Permit of Authorization to Construct an On-Site Sewage Facility Permit Valid For One Year From Date Issued

Permit Number: 116953

Subject: Re: Permit 116953

DRIP TUBING SYSTEM

OWNER:	SILAS JOSEPH PATERKA		DRA	WN BY: EJS III
STREET AD	2631 WESTERN SKIES DRIVE			
LEGAL DES	CYPRESS LAKE GARDENS - HIGH COUNTRY SECTION	BLOCK:	109	^{LOT:} 20
PREPARED	BY: GREG W. JOHNSON, P.E. F#002585 SCALE: 1"=30' DATE: 11/21	/2023	REVISED	11/27/2023

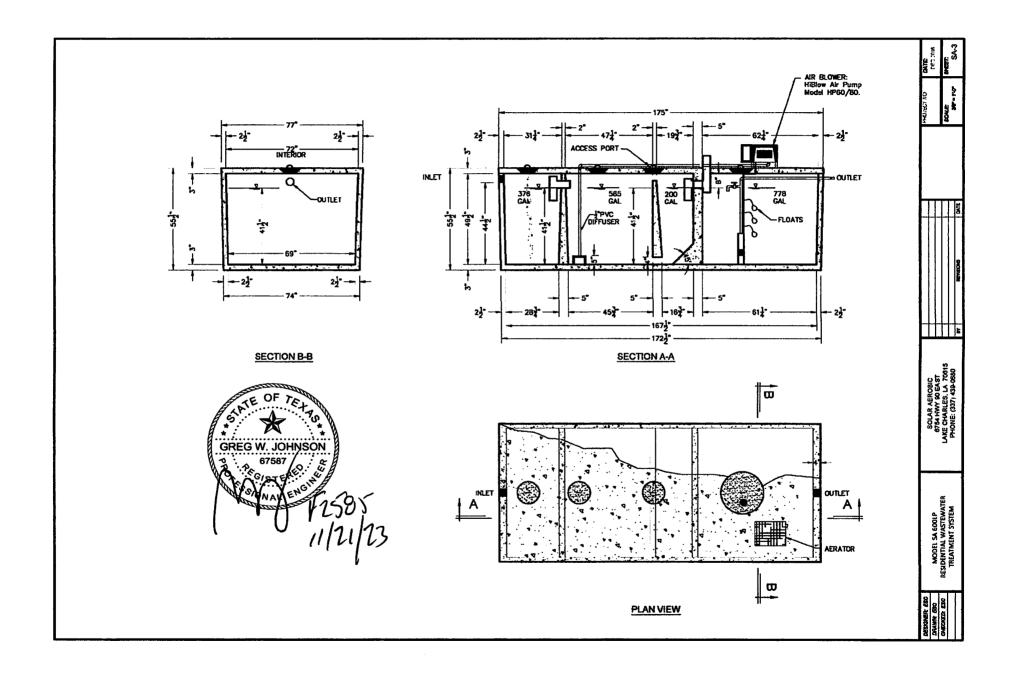
preliminary inspection was completed today and it was found that there is a drainage pipe which appears will discharge into the area of the proposed drip field. Please review site conditions and revise planning materials as needed.

In response to your comments, I revisited the site and located the reference drainage pipe about forty feet to the west of the property.

The drainage pipe discharge is not near the proposed drip field and will not have an impact on the proposed septic drip field.
